VIRGINIA ELECTRIC AND POWER COMPANY
SURRY POWER STATION UNITS 1 AND 2
PROPOSED LICENSE AMENDMENT REQUEST
CONTAINMENT SUMP INSPECTION SURVEILLANCE

ATTACHMENT 1
DISCUSSION OF CHANGE

PROPOSED TECHNICAL SPECIFICATIONS PAGES (MARK-UP)

INSERT 3

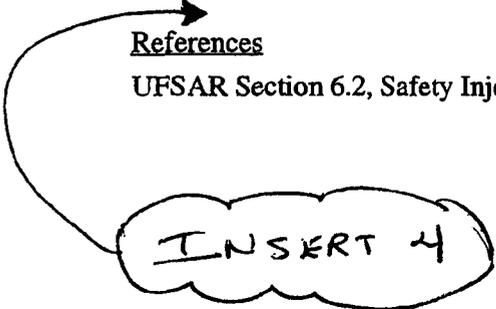
- c. Verifying, by visual inspection, that each low head safety injection pump suction inlet from the containment sump is free of debris that could degrade system operation. Perform each refueling outage and/or after major maintenance activities in the containment.

- c. Verifying by visual inspection that the low head safety injection containment sump components are not restricted by debris and show no evidence of structural distress or abnormal corrosion.
